**Notice of a Meeting**  
**Dalworthington Gardens Planning and Zoning Commission**

**June 12, 2023 at 6:00 p.m.**

Notice is hereby given that the Dalworthington Gardens Planning and Zoning Commission will hold a public hearing on June 12, 2023 at 6:00 p.m., and the Dalworthington Gardens City Council will hold a public hearing on June 15, 2023 at 7:00 p.m., both of which will be held in the Council Chambers, 2600 Roosevelt Drive, Dalworthington Gardens, Texas to consider the following: A replat application from Vitex Developments, LLC for existing Block 3, Lot 10, changing to Eleanor Estates, Block 1, Lots 1-6, with approximate current addresses being 2601 California Lane and 2615 California Lane, Dalworthington Gardens.

Project Name and Address  
 ELEANOR ESTATES  
 DALWORTHINGTON GARDENS,  
 TEXAS

Pond Outflow

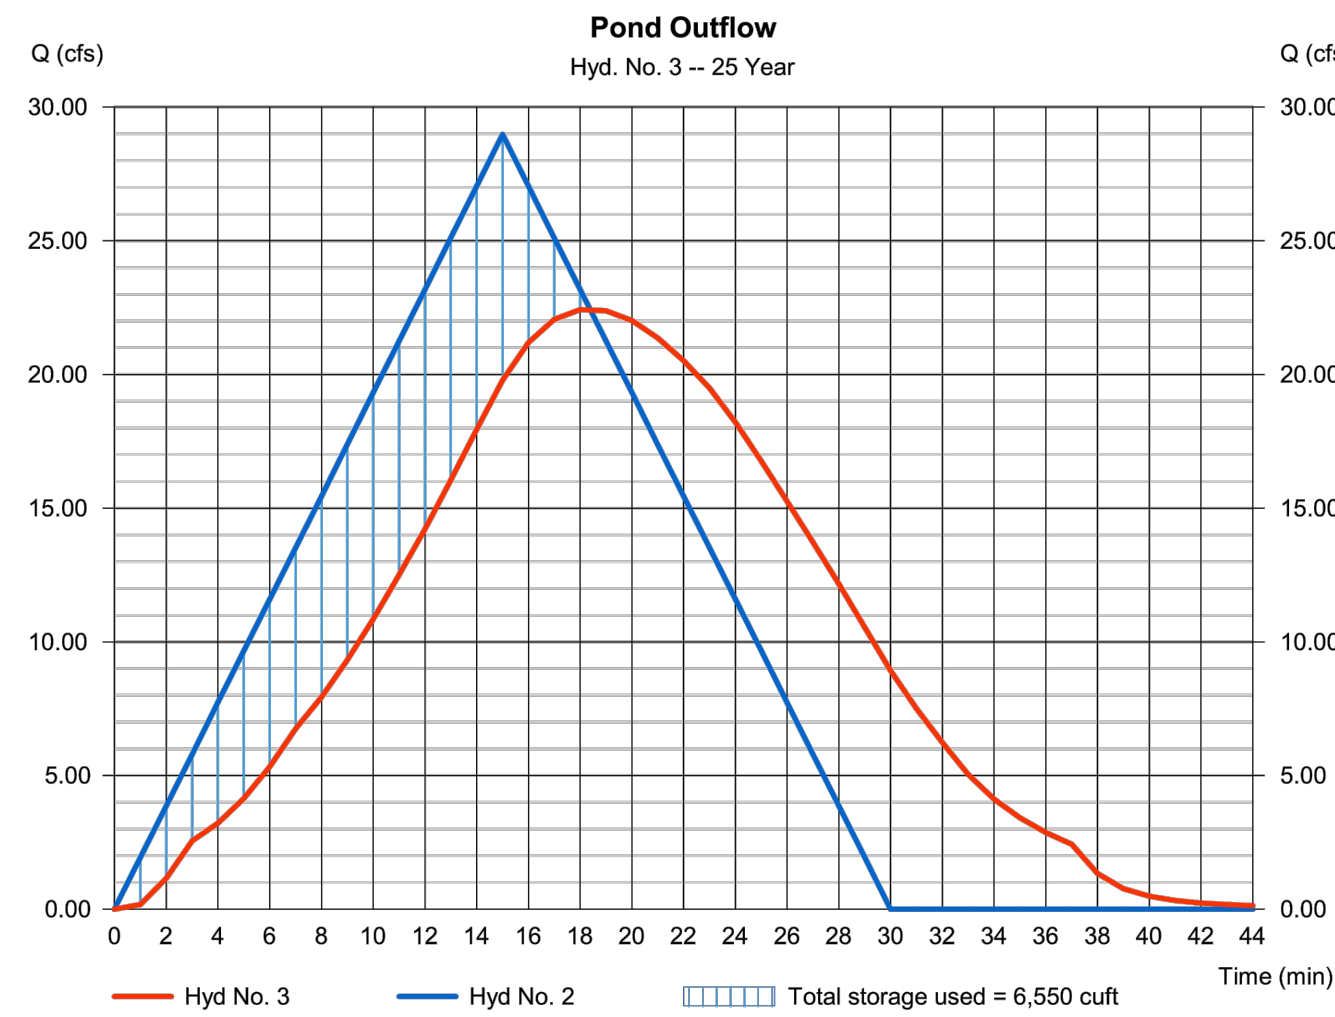
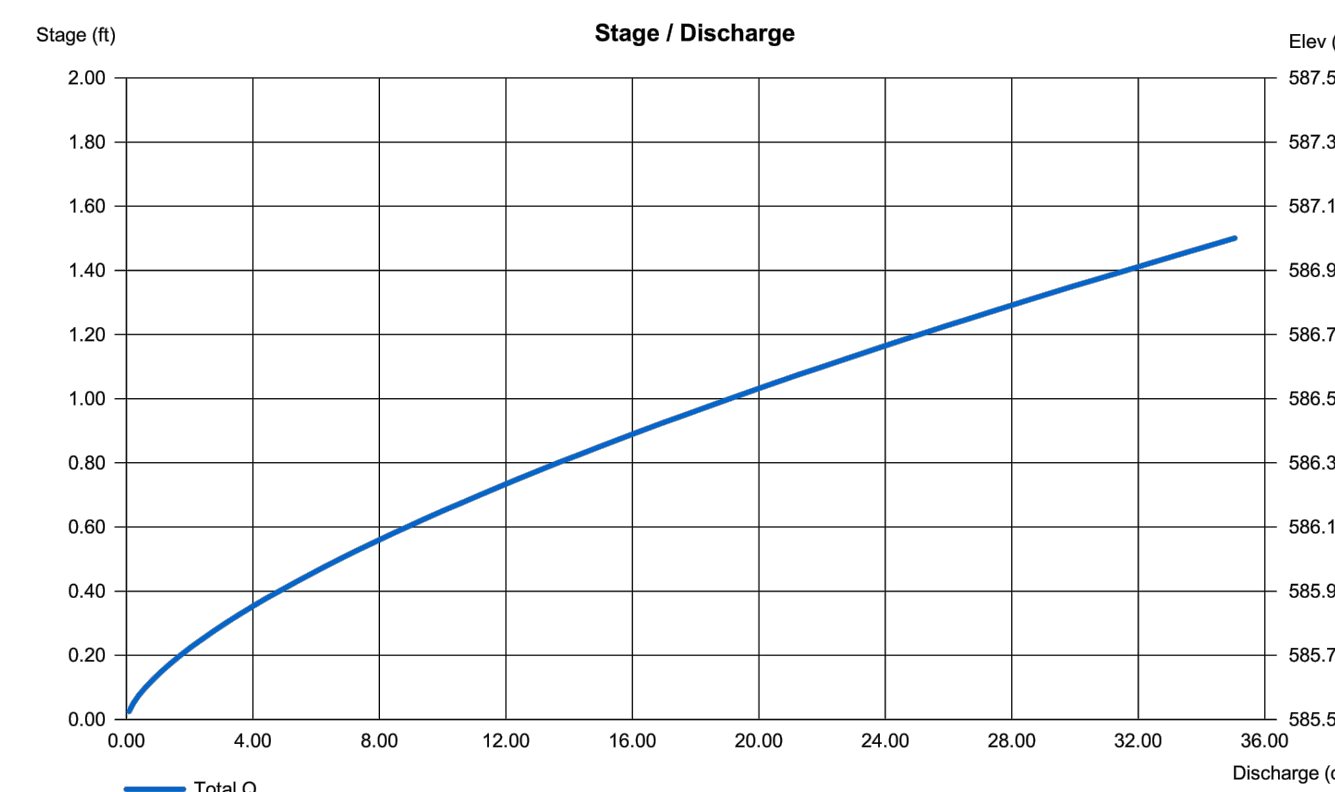
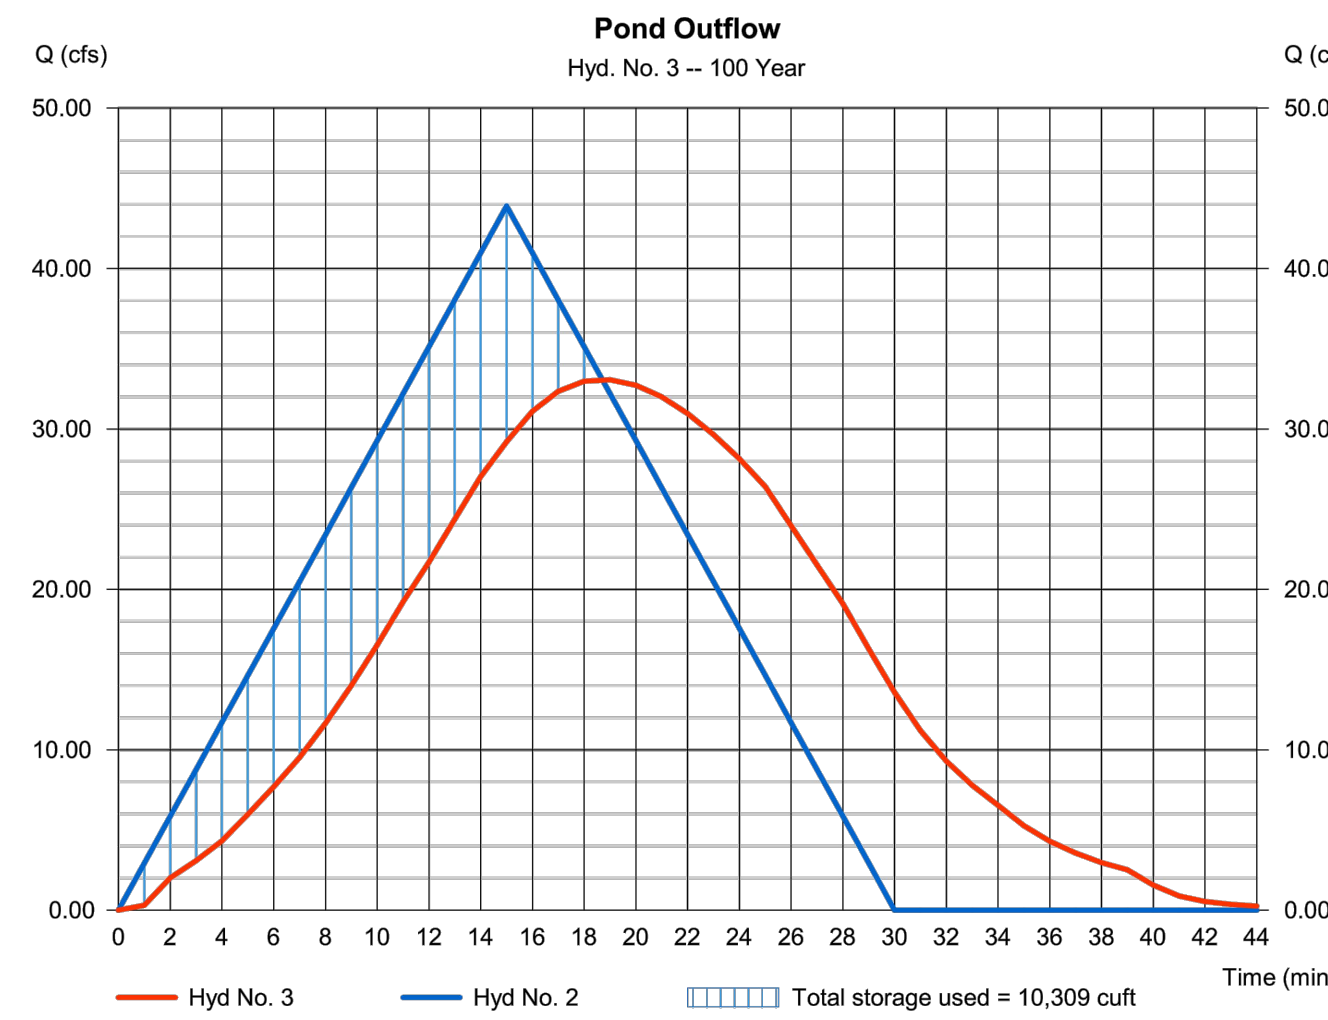
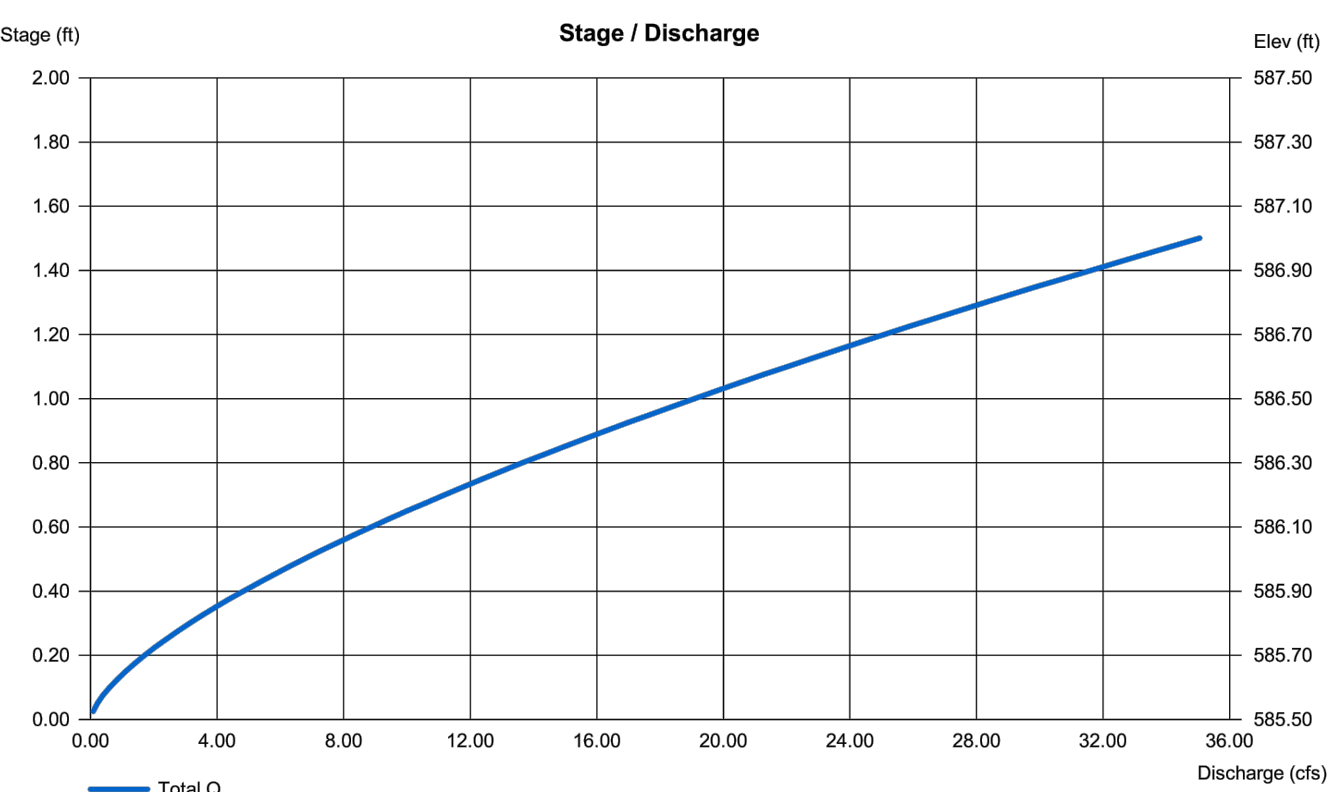
Please add the pond volume at 100-yr WSEL

**Response: Pond volume is provided in the Hydrograph report table** (Completed)

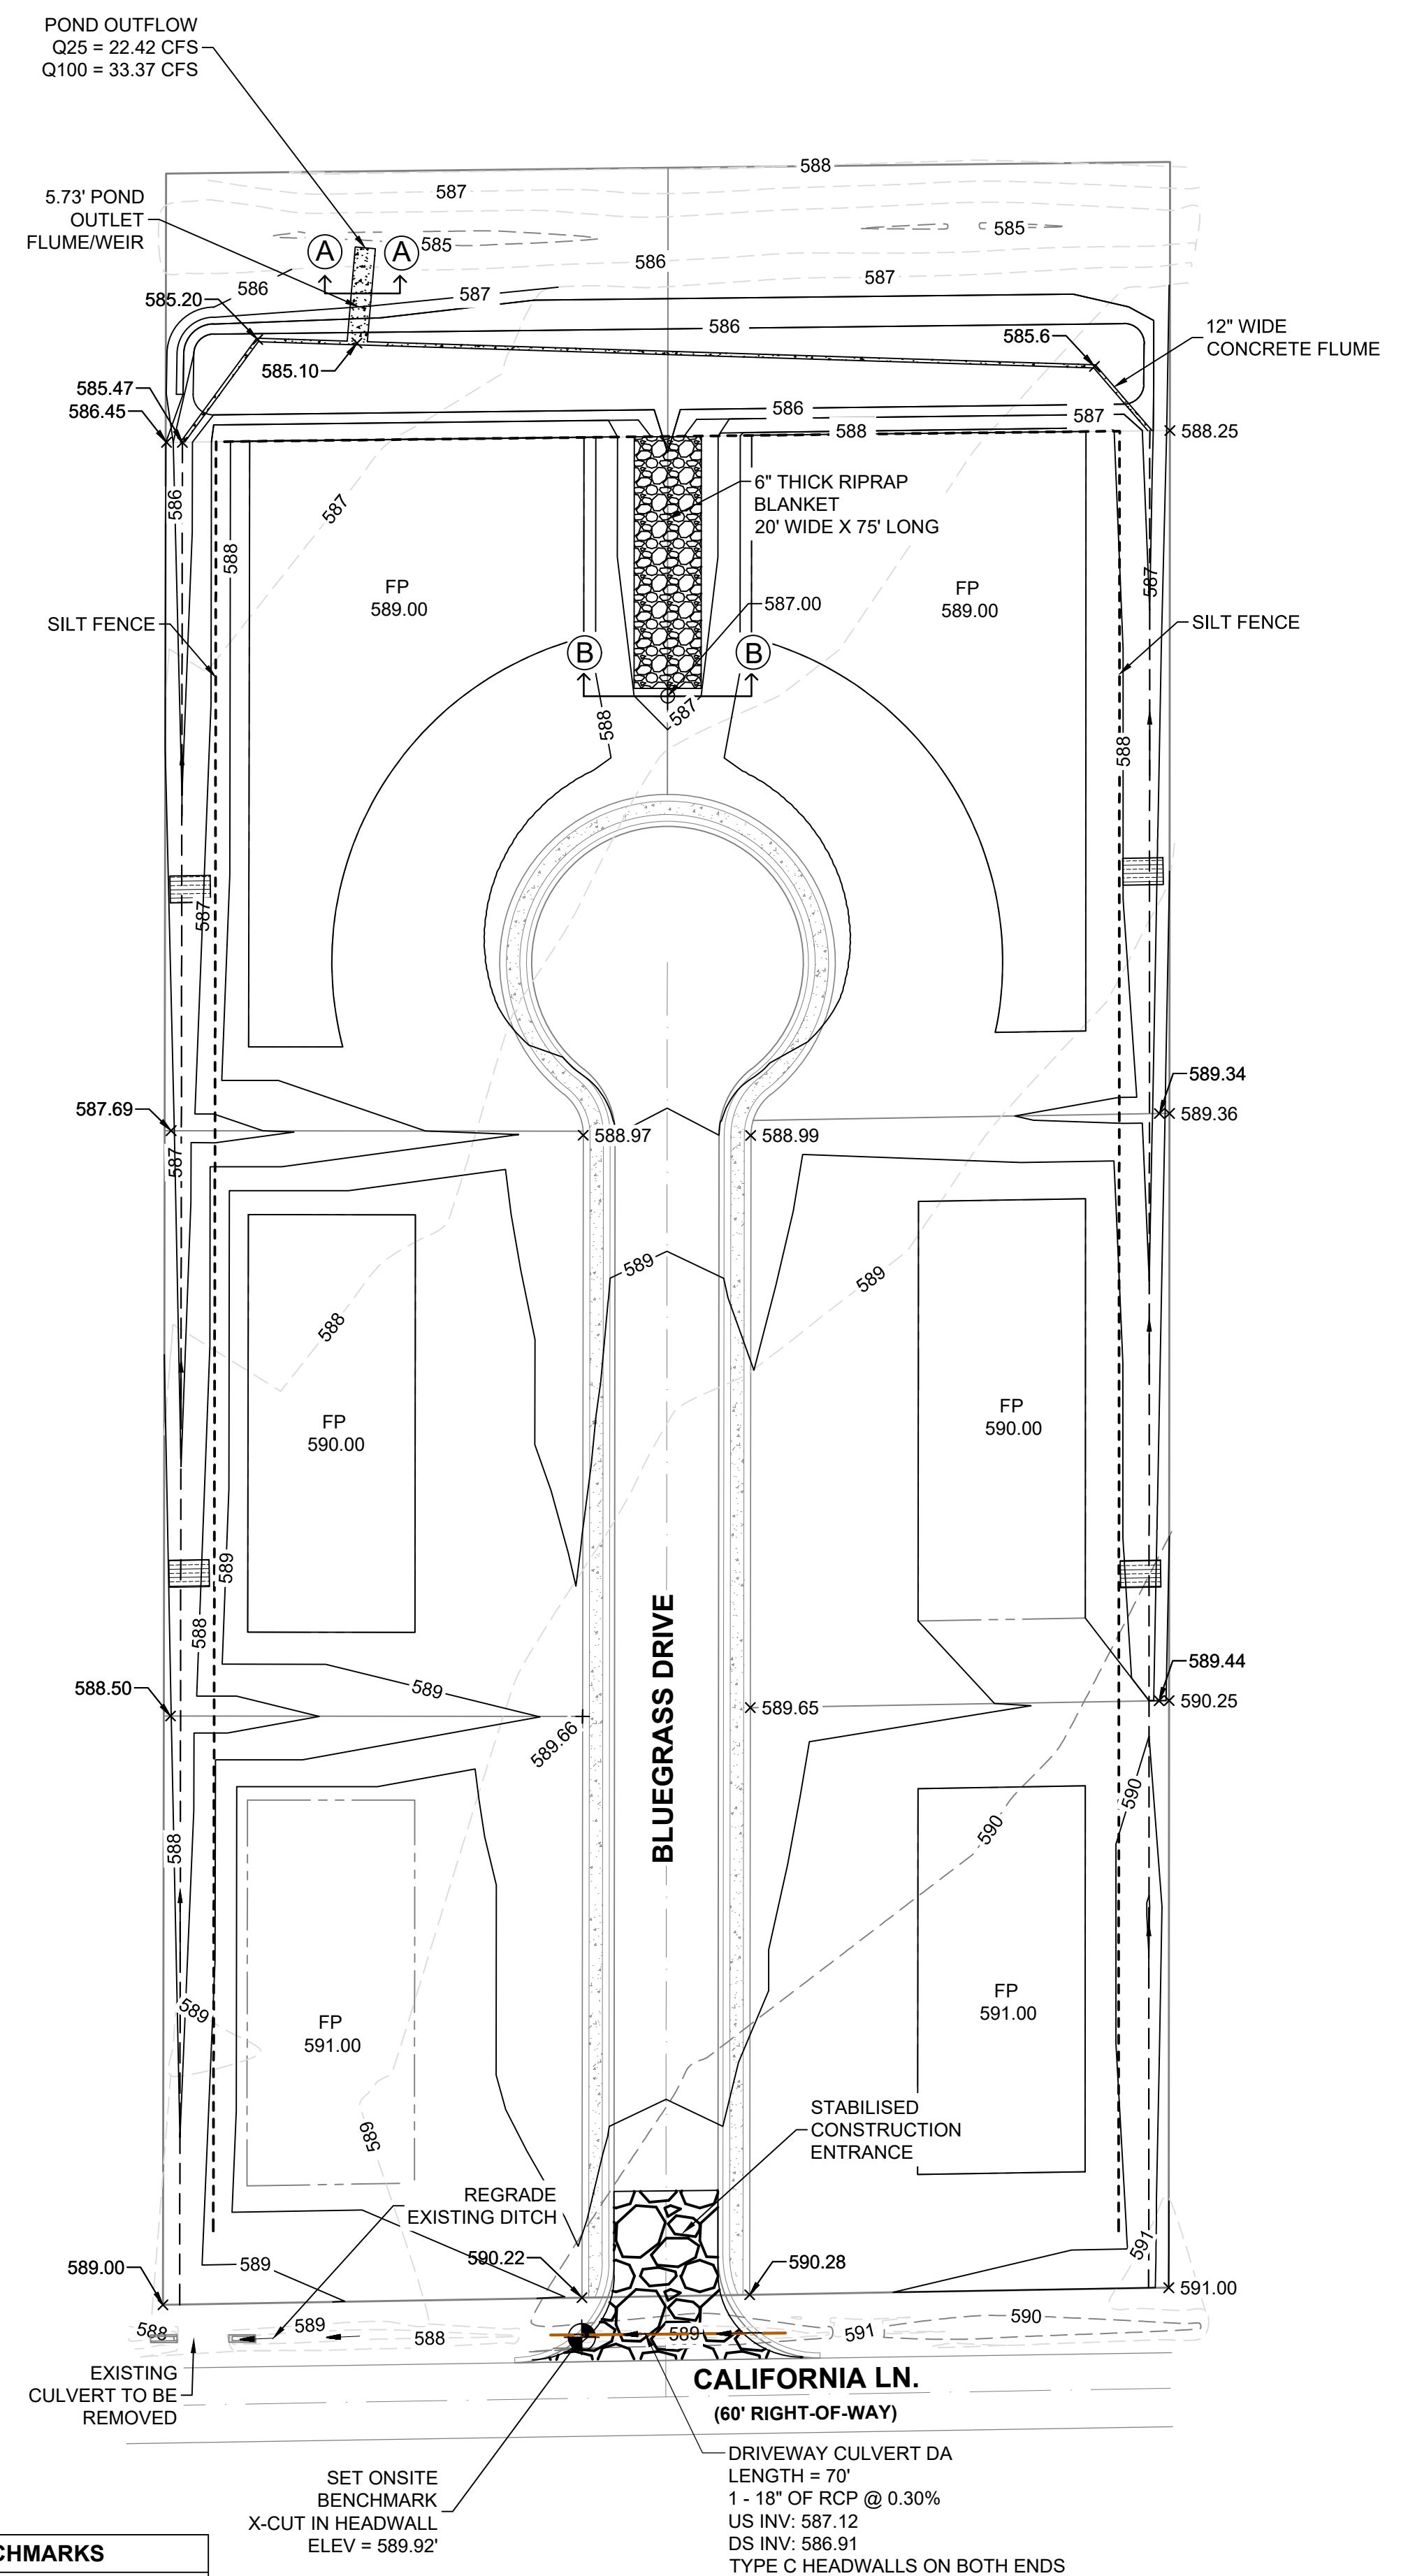
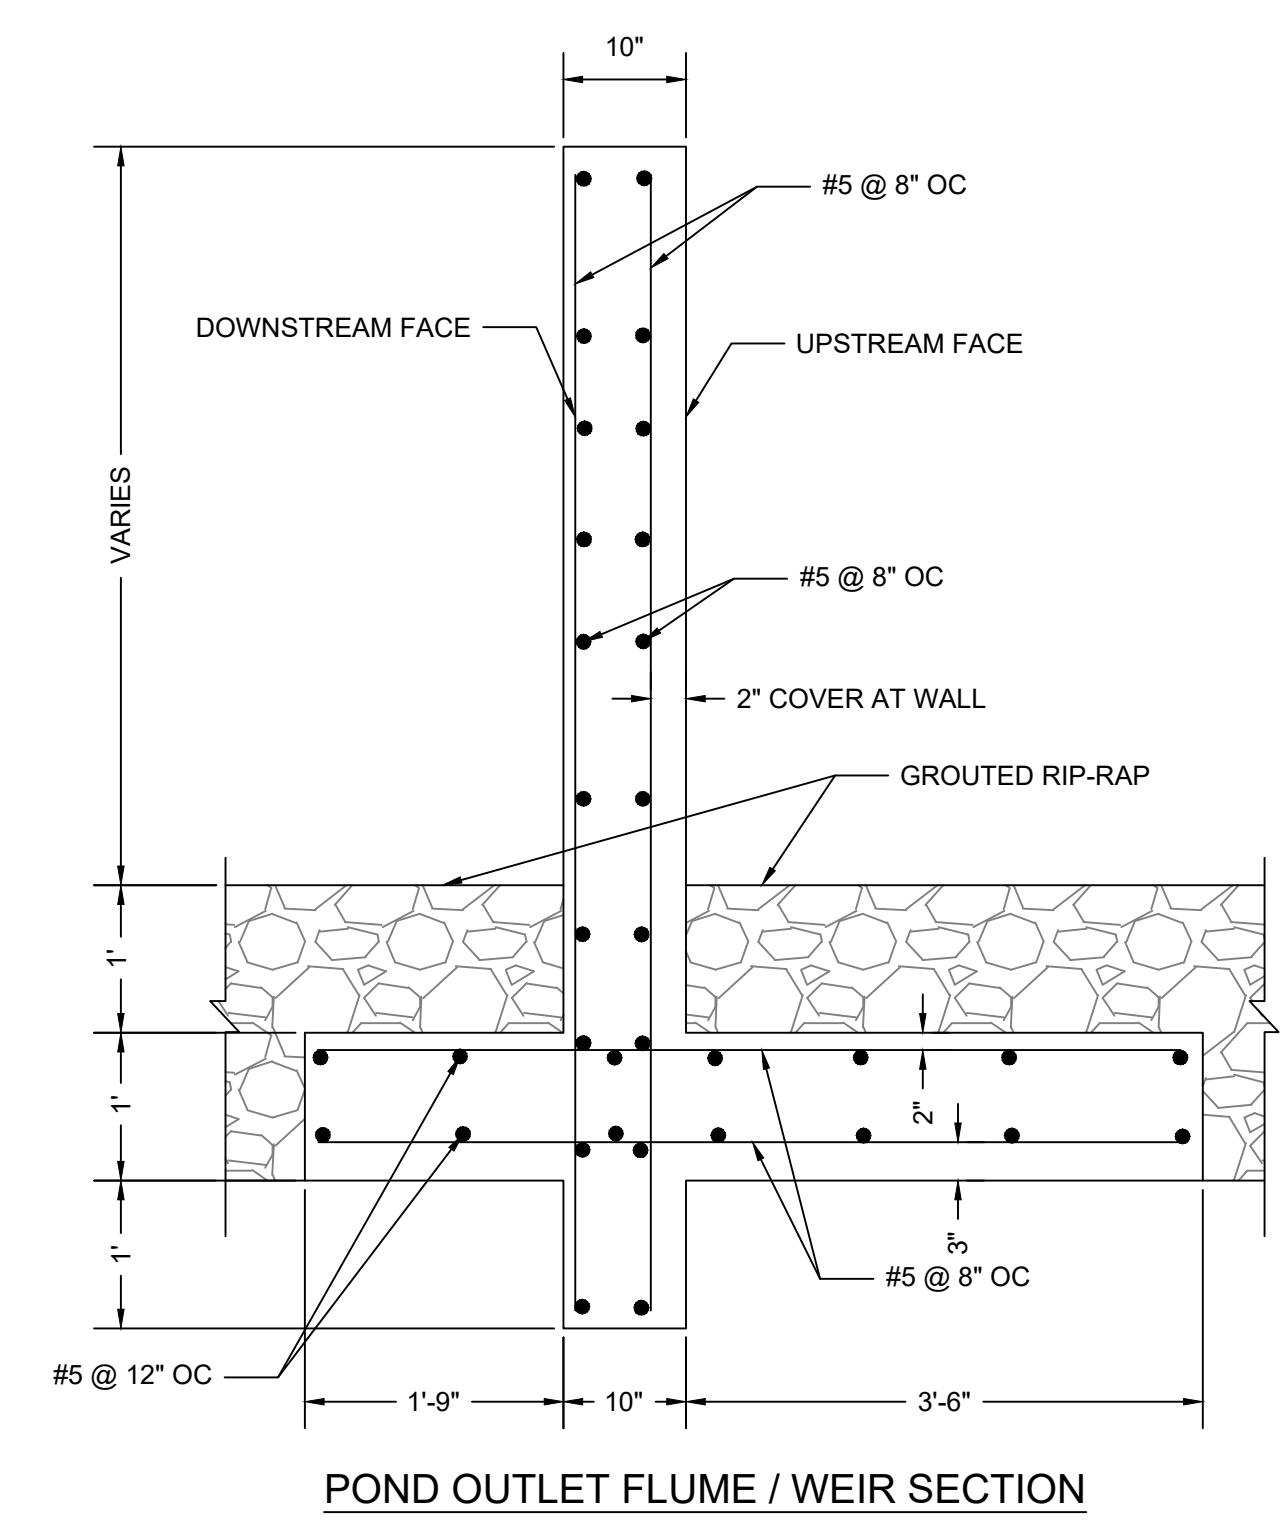
Please add allowable release of pond.

Please provide cross section of swale. Add Qcap and 100-year WSEL

Please show location of silt fence

Please add reference at least two reference benchmarks.

**Response: Flume/Wier discharge added here in the updated sheet** (Completed)

**Response: Updated sheet provides cross section B for this swale and includes 100yr WS and flow capacity** (Completed)

**Response: Silt fence added as requested.** (Completed)

**Response: This information added as requested** (Completed)
